NUREG-2182
Volume 1

Final Safety Evaluation Report for the Combined License for Enrico Fermi 3

Docket Number 52-033

DTE Electric Company

Figure 2.4.3-1. Hourly Distribution of the Probable Maximum Precipitation for the Swan Creek Watershed

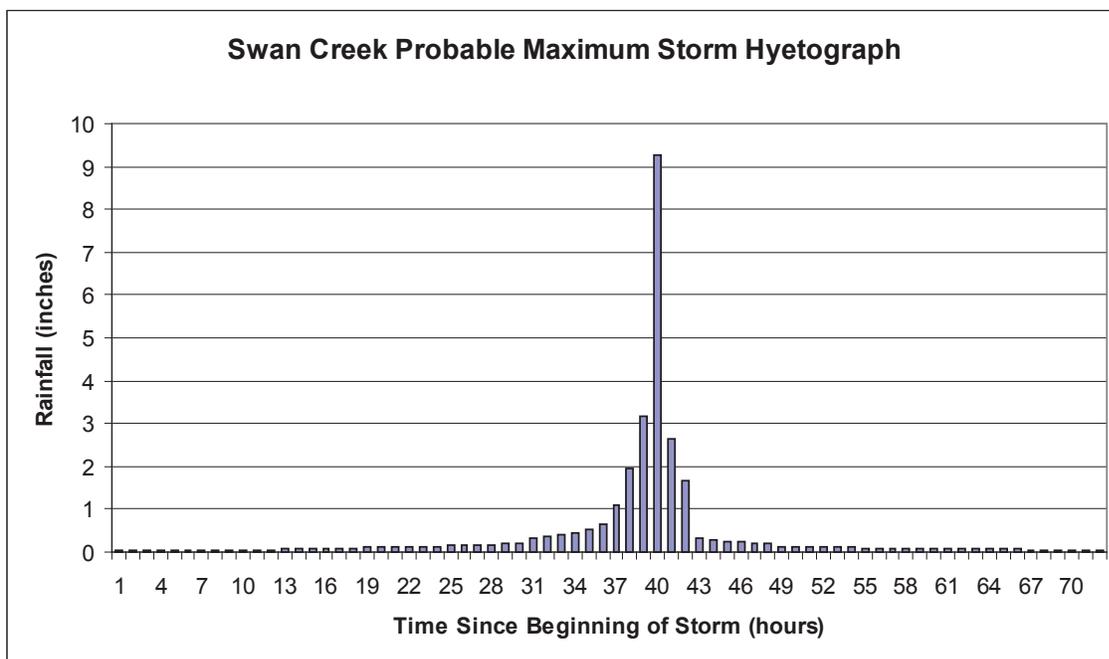
The applicant's input and output values for the HMR-52 program were very similar to the staff's. Both the staff and the applicant used a value of 0.302 for the ratio of the 1 to 6 hour storm. The staff found a maximum storm orientation of 309 degrees and the applicant found a maximum storm orientation of 311 degrees. The depth-area-duration curves used by the applicant were slightly larger overall than those used by the staff, and thus the applicant's analysis was more conservative. Therefore, the applicant's input values were found to be acceptable. The applicant calculated a PMP of 28.9 from the HMR-52 software, the same value determined by the staff's calculation.

The staff-calculated PMP with snowmelt for the Swan Creek Watershed shown in Figure 2.4.3-1 above can be directly compared to Figure 2.4-XX-3 submitted by the applicant with the response to RAI 2.4.2-1, dated September 30, 2009 (ADAMS Accession No. ML092790561). The staff finds the applicant’s calculation of PMP with snowmelt to be acceptable, because the applicant’s PMP is the same as the value calculated by the staff.

Figure 2.4.3-3. Probable Maximum Flood Runoff using HEC-HMS 3.1.0 Rainfall-runoff Model

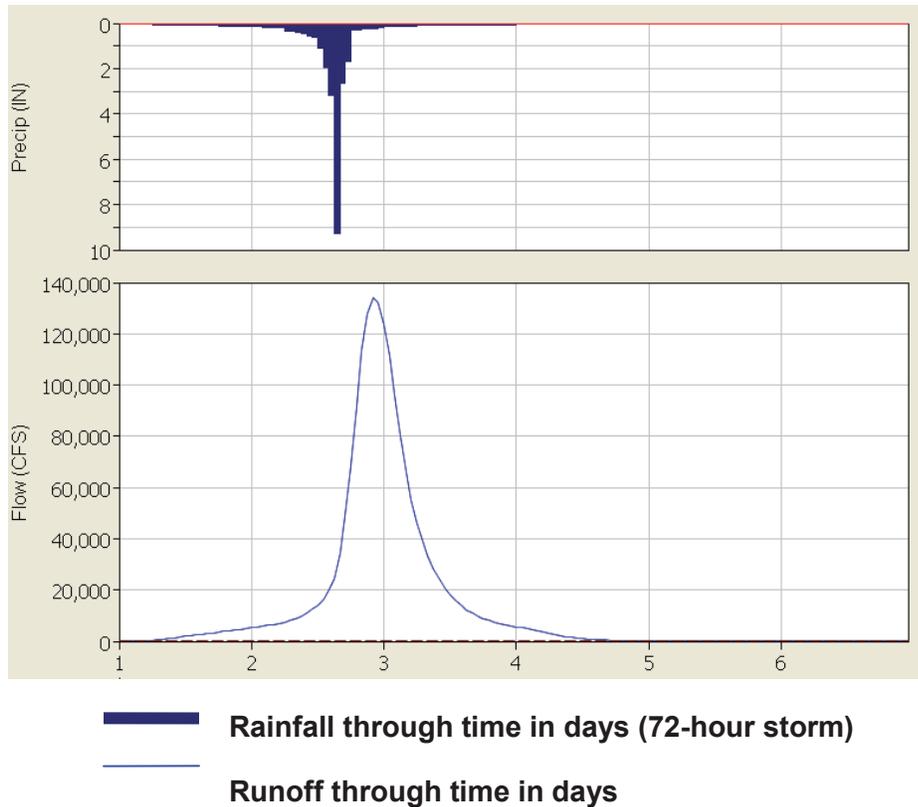
In Figure 2.4.3-3, the staff developed flood hydrographs based on the parameters discussed above. By developing an independent hydrograph, Figure 2.4.3-3 can be directly compared with Figure 2.4-219 of the FSAR to examine the PMF runoff calculated by the staff versus the PMF runoff calculated by the applicant.

Figure 2.4.3-4. Probable Maximum Flood with Snowmelt Runoff using HEC-HMS 3.1.0 Rainfall-Runoff Model

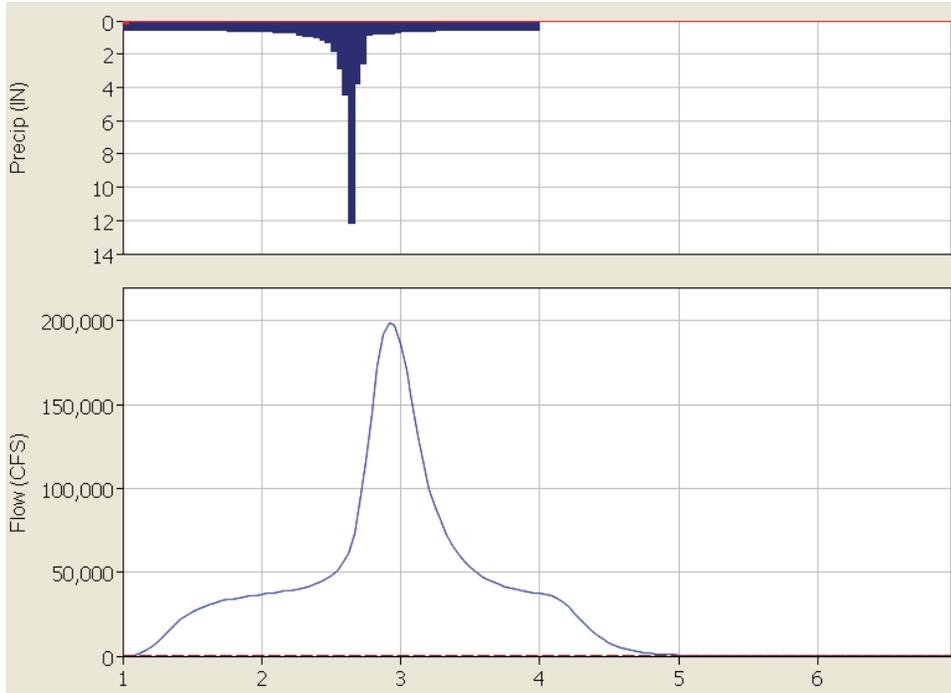
The NRC staff independently calculated the PMF with snowmelt for Swan Creek and obtained a value of 199,000 cfs, which is approximately 18 percent higher than the value presented in the response to RAI 2.4.2-1, dated September 30, 2009 (ADAMS Accession No. ML092790561).

In Figure 2.4.3-4, the staff independently developed a flood hydrograph that include snowmelt. The staff hydrograph in Figure 2.4.3-4 can be directly compared with Figure 2.4-2-XX-4 of the response to RAI 2.4.2-1, dated September 30, 2009 (ADAMS Accession No. ML092790561) to examine the runoff from the PMF plus snowmelt calculated by the staff versus the PMF plus snowmelt runoff calculated by the applicant.

Figure 2.4.5-3. Cross Section from the STWAVE Point to the Fermi 3 Safety-Related Structure

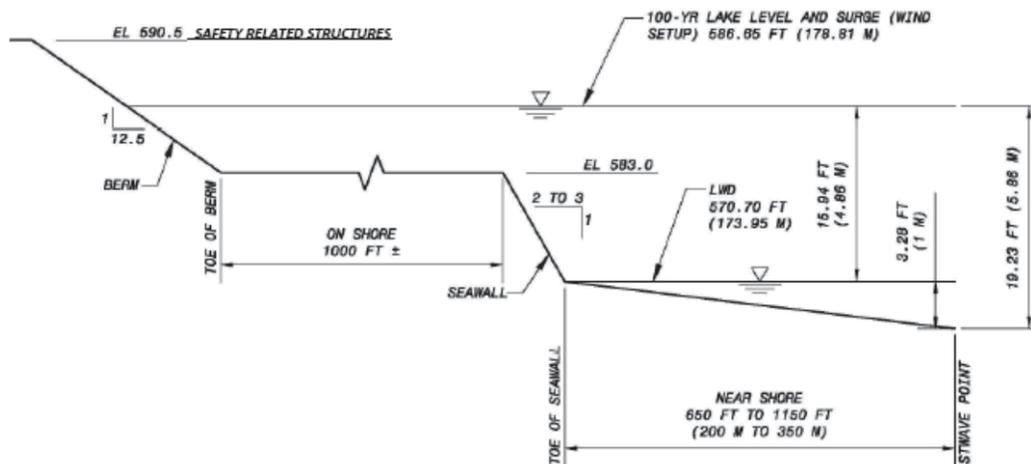
breaking and run-up mainly depended on the total water depth, which is sum of wave set-up and still water depth. The applicant, however, did not provide a discussion on the change in total water depth due to the wave set-up across the shore. Therefore, the staff requested that the applicant use graphs to illustrate the shore profile (from an STWAVE point to the Fermi 3 safety structures), wave characteristics across the shore (maximum still water level, wave length, wave height, breaking wave, run-up, etc.), their relationship, and quantitative information that supports conclusion of no impact to Fermi 3 safety structures. RAI 2.4.5-8, dated January 29, 2010 (ADAMS Accession No. ML092870355) was issued to the applicant.

In response to RAI 2.4.5-8 the applicant provided the information regarding the cross section from the STWAVE point to the Fermi 3 safety structures and the calculated the wave characteristics across the shore (Figure 2.4.5-3). The staff verified that all information is correct by checking the cross section data to that information used in the model. The shore profile data were used in the model input for the calculation of the breaking wave and wave run-up.

Figure 2.5.2-9 Plot Comparing the Staff's and the Applicant's 1-Hz Total Mean Hazard Curves for the Distributed Seismicity Source Zones

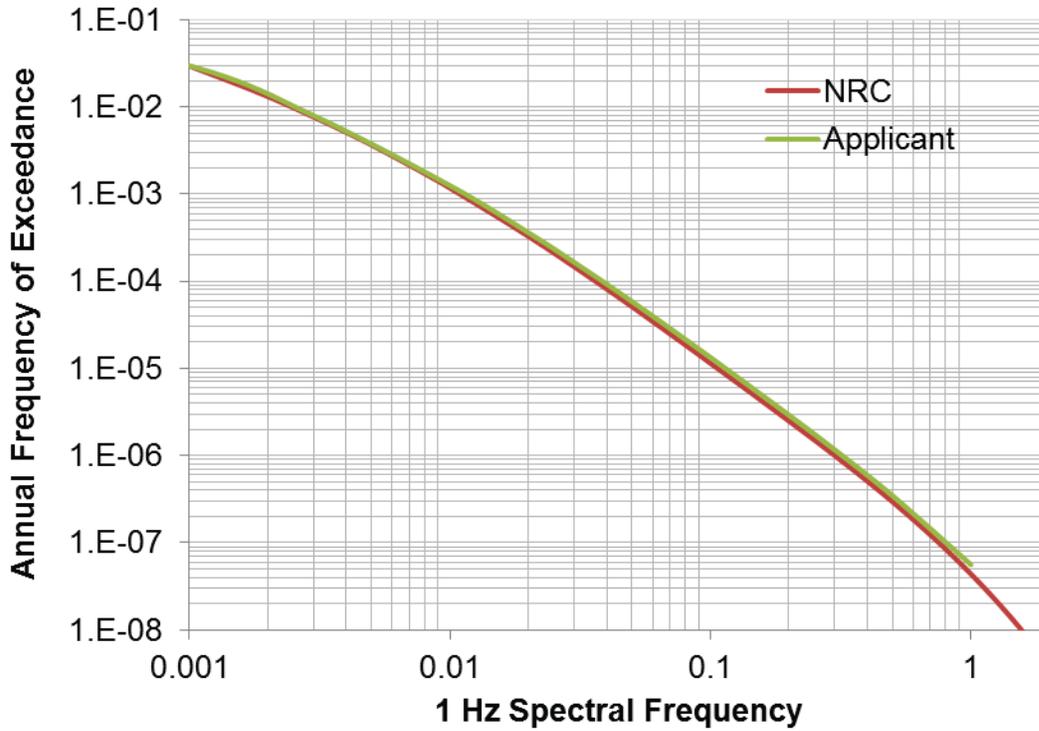
To determine the adequacy of the applicant's PSHA calculations, the staff performed its own confirmatory PSHA calculation for the Fermi 3 site. The staff used the CEUS-SSC model (NUREG-2115) along with the EPRI (2004, 2006) GMM. The staff conducted the PSHA for the Fermi site using a source distance radius of 1,000 km (620 mi) for the CEUS-SSC-distributed seismicity sources. The staff's calculation did not include the RLME source zones. Therefore, the staff compared its confirmatory 0.5, 1, 2.5, 5, 10, 25, and 100 Hz hazard curve results with the applicant's results for the distributed seismicity sources and determined that the two sets of results are almost identical. This finding is illustrated in Figures 2.5.2-9 through Figure 2.5.2-11 in this SER showing the PSHA hard rock hazard curve results for 1, 10, and 100 Hz, respectively, for the distributed seismicity sources.

Figure 2.5.2-11 Plot Comparing the Staff's and the Applicant's 100-Hz Total Mean Hazard Curves for the Distributed Seismicity Source Zones

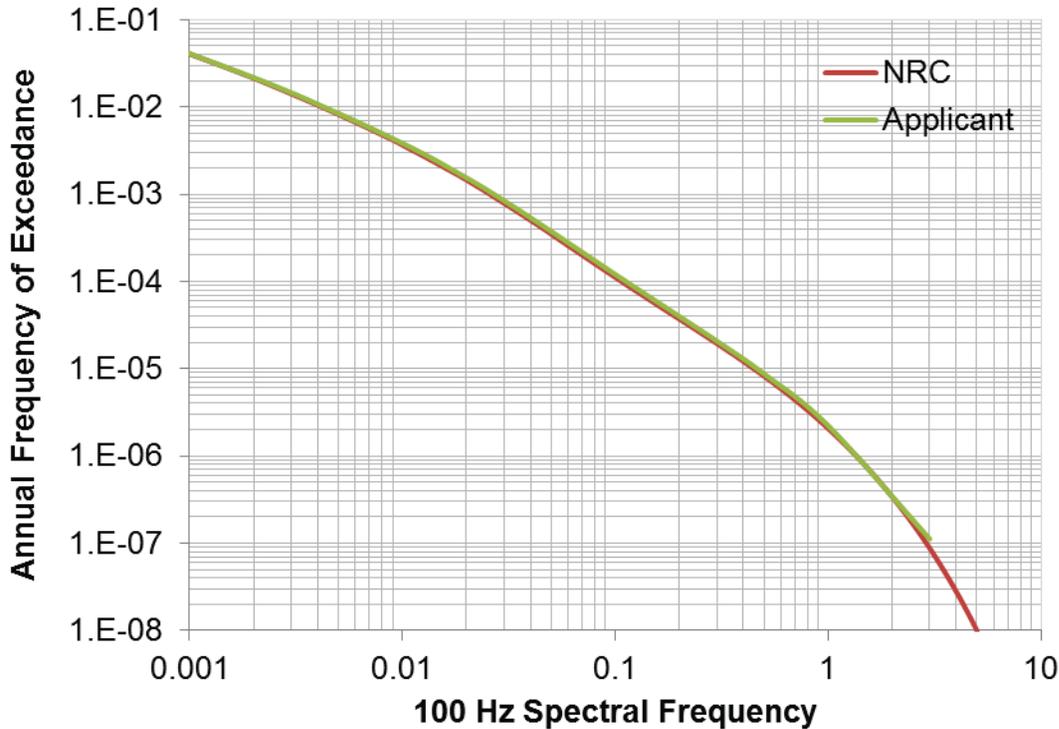
Based on the above assessment, the staff concluded that the applicant's PSHA calculations adequately characterize the seismic hazard at the Fermi 3 site in terms of the contribution from the distributed seismicity sources. Because the staff's calculation did not include the RLMEs, the staff determined that the applicant had selected the appropriate RLME sources (i.e., the NMFS, WA, CHV, and CHS) based on their contribution of 1 percent or greater to the total mean hazard.

Figure 2.5.2-12 Comparisons of the Staff's Site Response Amplification Functions with the Amplification Functions Determined by the Applicant

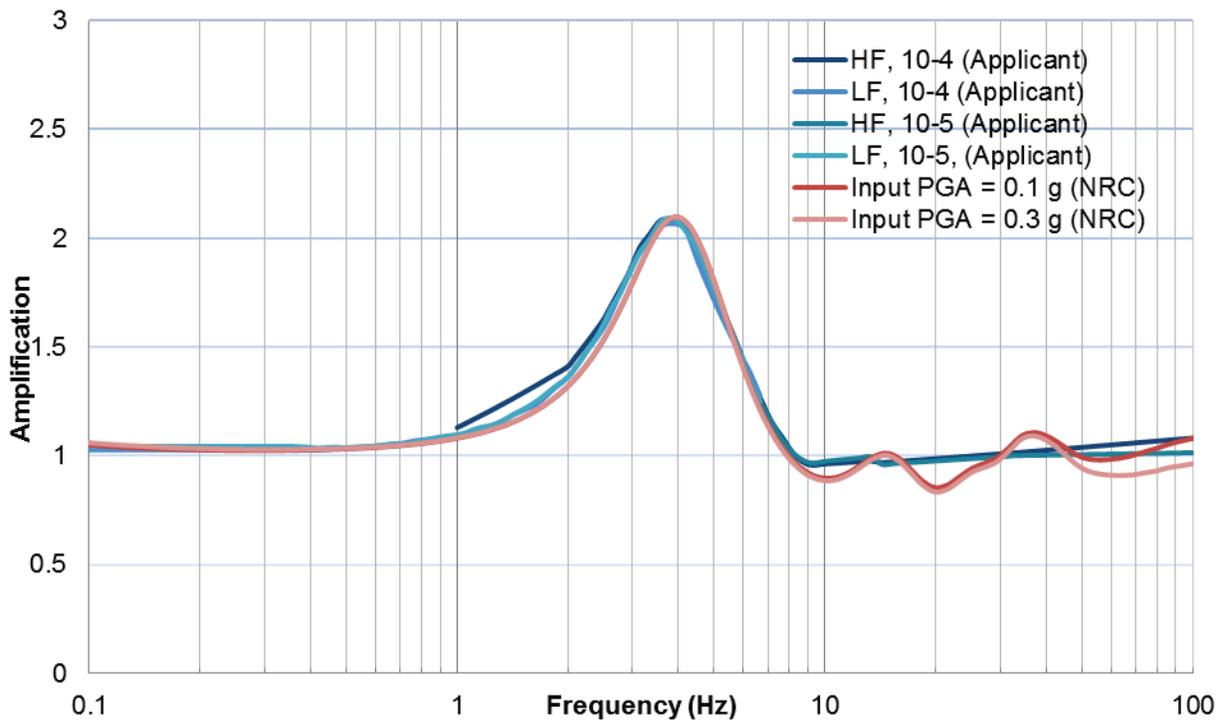
To determine the adequacy of the applicant's site response calculations, the staff performed confirmatory site response calculations. As input, the staff used the static and dynamic soil properties in FSAR Section 2.5.4 and summarized in FSAR Table 2.5.2-213. The staff performed site response calculations using the RVT methodology with 7 spectral frequencies and 11 input rock amplitudes. The use of RVT in site response calculations is mentioned in RG 1.208 as an acceptable alternative to the time series approach. The staff's site amplification function results are compared with the applicant's results in Figure 2.5.2-12 in this SER.

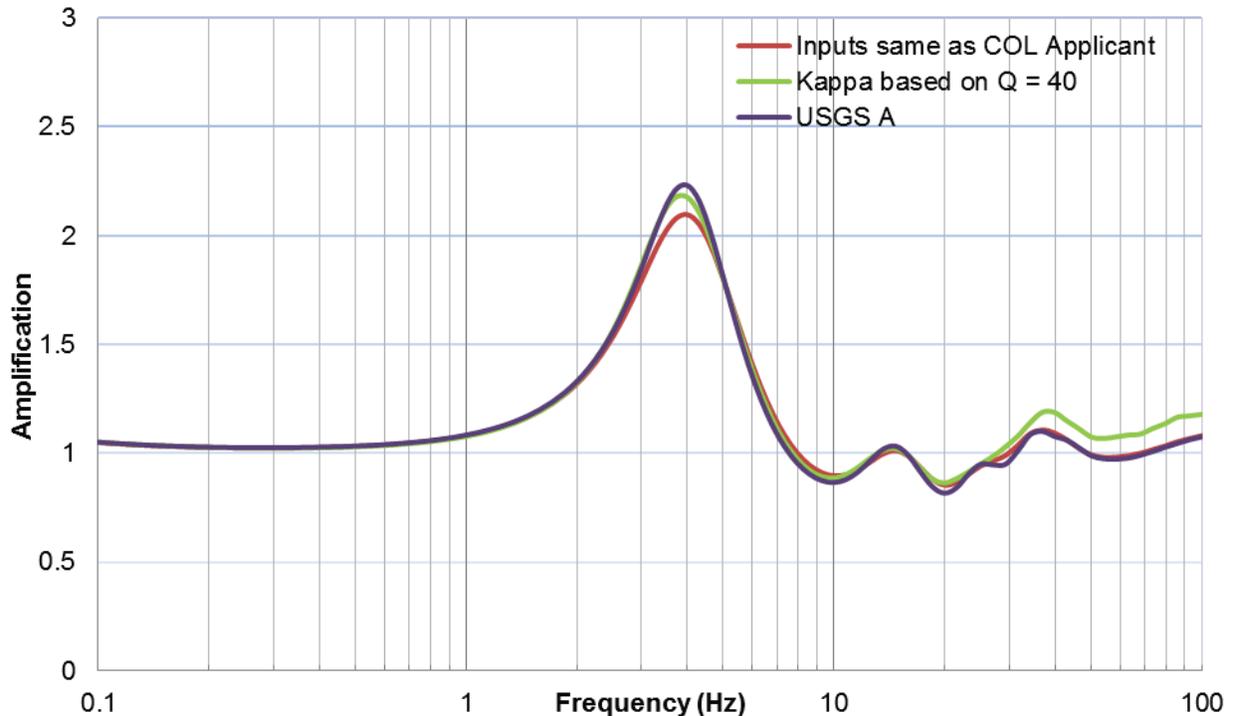
Based on the above assessment, the staff concludes that the applicant's site response calculations adequately characterize the Fermi 3 site effects.
